LOS ALAMOS TECHNICAL EVALUATION REPORT

On-Site Audit of Dresden Nuclear Power Plant Emergency Core Cooling System Strainer Blockage Resolution

**TECHNICAL EVALUATION OF ECCS STRAINER DESIGN AND PERFORMANCE ANALYSIS
AUDIT OF DRESDEN UNITS 2 AND 3 RESPONSE TO NRC BULLETIN 96-03**

**Figure 2. Dresden ECCS Pump and Ring-Header Arrangement.
(Ref. Licensee Documents)**

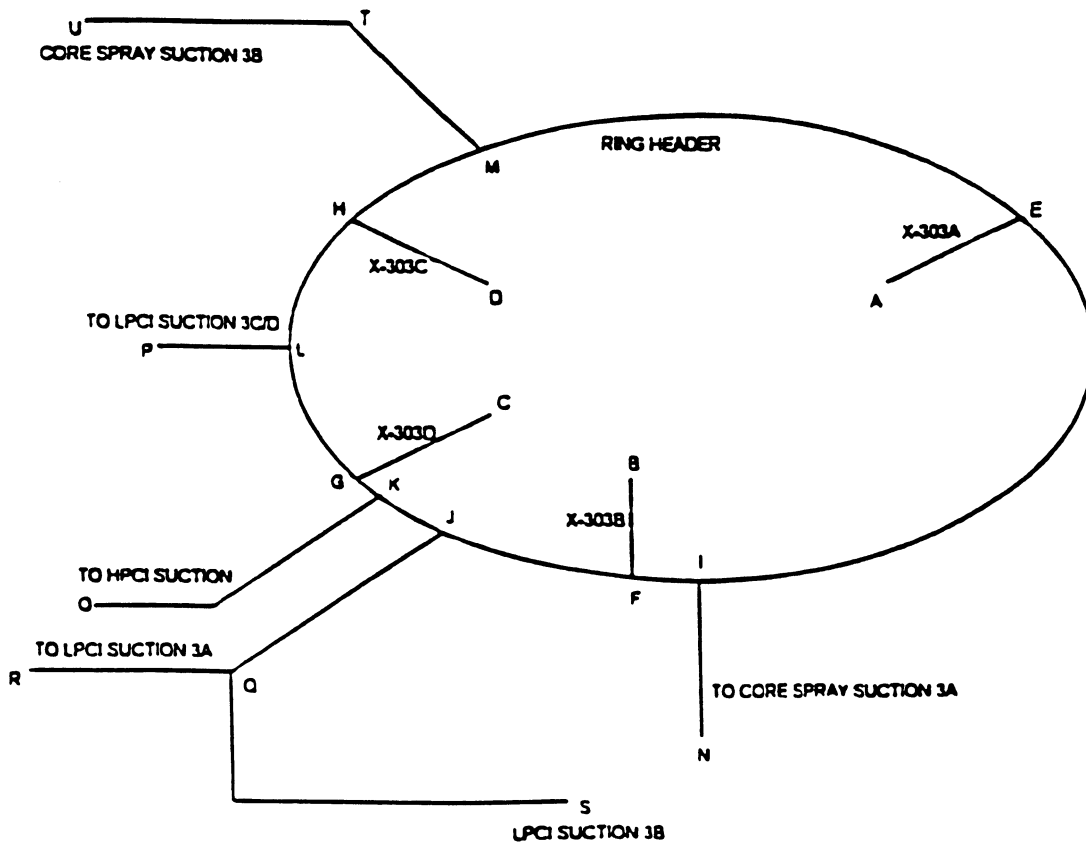
Figure 2 shows the locations where the ECCS strainers are connected to the ring header. As shown here, four strainers are used to process the inlet flow. The pre NRCB96-03 licensing basis assumes that the strainer closest to the most limiting pump would be lost, and the three remaining strainers would be available. During short-term operation, this results in an estimated flow of 10,733 gal./min through each

strainer following a LOCA and SF-LSL failure and in a flow of 6333 gal./min during long-term. The licensee used these flow rates in the $NPSH_{\text{Margin}}$ calculations performed for the pre-NRCB 96-03 strainer/plant configuration.

The licensee analyses/assumptions relative to the ECCS operating parameters appear reasonable. The NRC staff reviewed these ECCS operating parameters and approved them for use in pre-NRCB 96-03 $NPSH_{\text{margin}}$ evaluations. The licensee retained the same values.

Fig. 3. $NPSH_{margin}$ estimated for LPCS-3B for pre NRCB 96-03 strainer configuration.
(These values were reviewed and approved by the NRC staff)

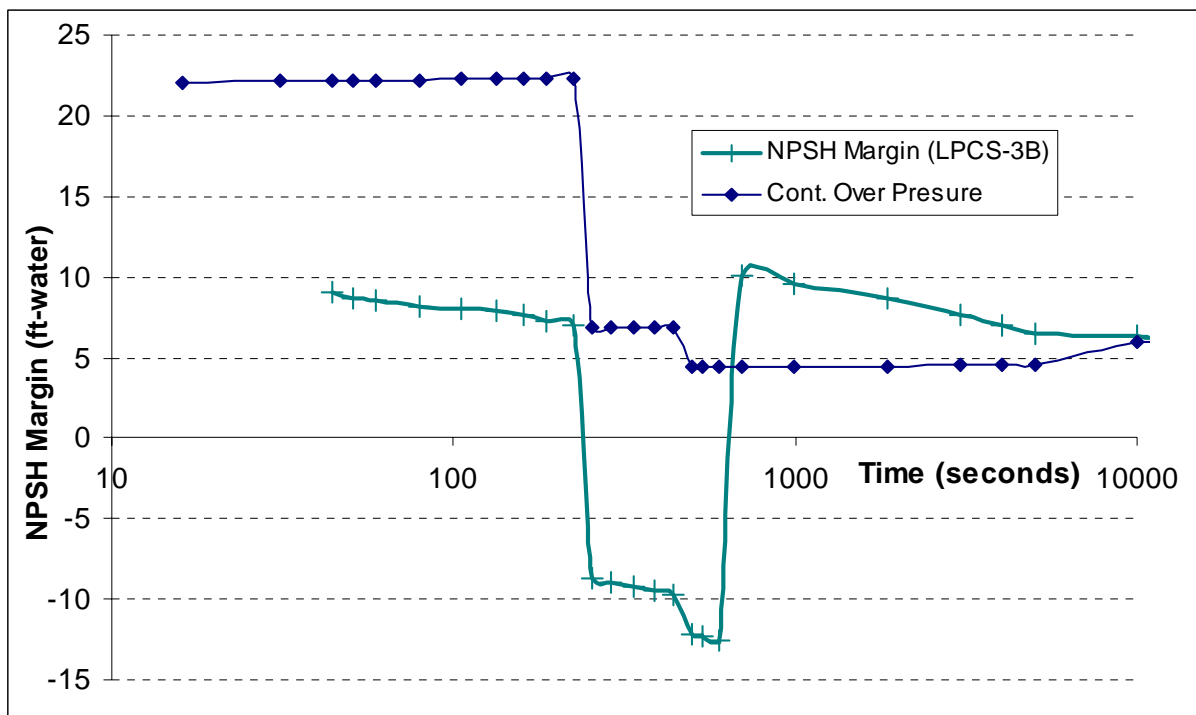
The limiting LPCI and LPCS pumps are LPCI-3B and LPCS-3B, respectively, attached to nodes S and U in Fig. 2. For these and possibly other LPCI/LPCS pumps during short-term operation (i.e., before the operator throttles the ECCS), the $NPSH_{margin}$ as calculated by the licensee was less than 0. This negative margin was projected to occur between 4 and 10 min after the LOCA and was calculated to be as high as -12 ft-water. There are two primary reasons for the estimated negative $NPSH_{margin}$.

- The analyses were based on old strainer geometries, which resulted in head losses in excess of 6 ft-water because of flow through a small screen area. The analyses also assumed that only three strainers (connected to nodes A, B, and C) of Fig. 2 are operational, which maximized head loss across the clean strainer as well as head loss caused by piping that connects the strainers to the ring header (i.e., nodes A, B, and C to nodes E, F, and G, respectively)
- The $NPSH_{required}$ values for the LPCI and LPCS pumps are large. This is a characteristic of the pumps in service.

The NRC staff approved operation of Dresden under negative $NPSH_{margin}$ for a limited time (<10 min) because (a) the Quad Cities and Dresden plants have shown that their ECCS pumps can operate under cavitation for 1 h without significant loss of functionality, and (b) the Dresden EOPs call for pump throttling even at times shorter than 10 min if cavitation effects are observed.

Fig. 5. Fouled Strainer NPSH_{margin} for the Limiting ECCS Pump (LPCS-3B). Replacement Strainers. All four strainers Operational. Based on LANL analyses.

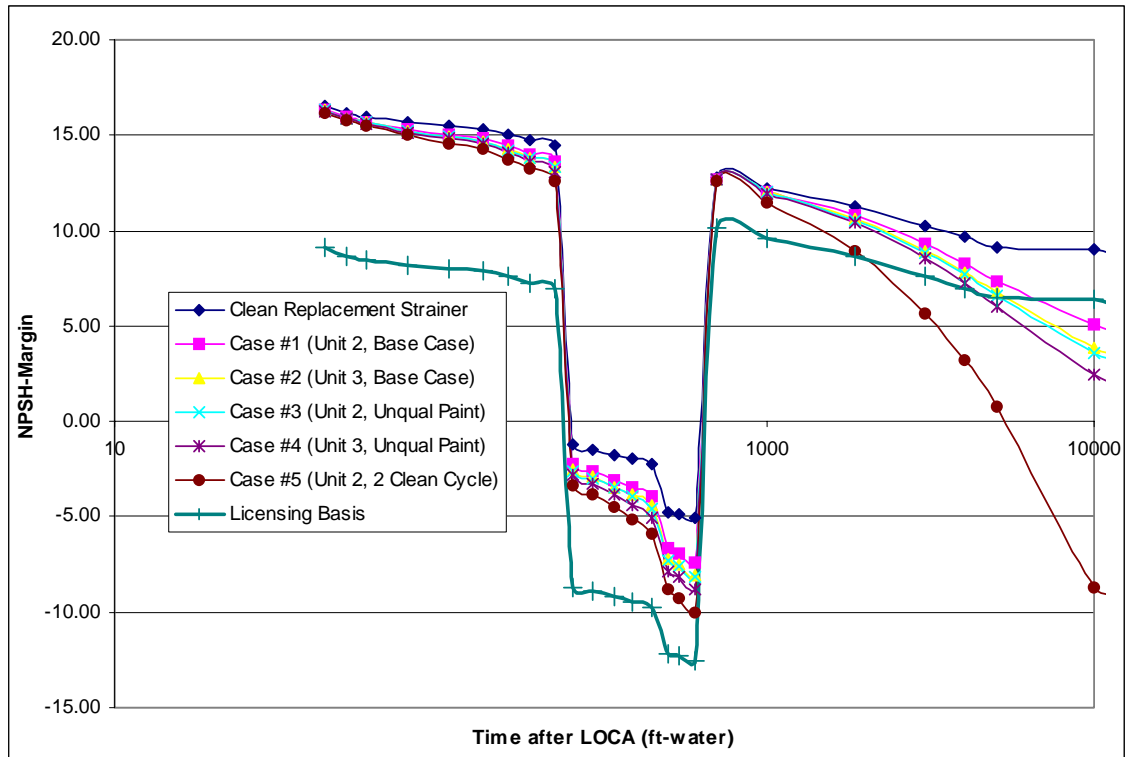
Based on our calculations, it is our view that the strainers are reasonably sized for debris loadings under Cases 1 through 4. The strainers are not properly sized to handle Cases 5 through 8. However, we recognize that our calculations are associated with several conservative assumptions. These calculations demonstrate that the strainers can handle (1) higher debris loadings estimated by LANL and (3) the impact of differences in head loss methodology. This conclusion, however, is only valid if the licensing basis long-term flow is 19,000 gal./min. Note that at flow rates higher than 19,000 gal./min, even the clean strainers would result in negative NPSHMargin; and the debris accumulation makes the case even worse.
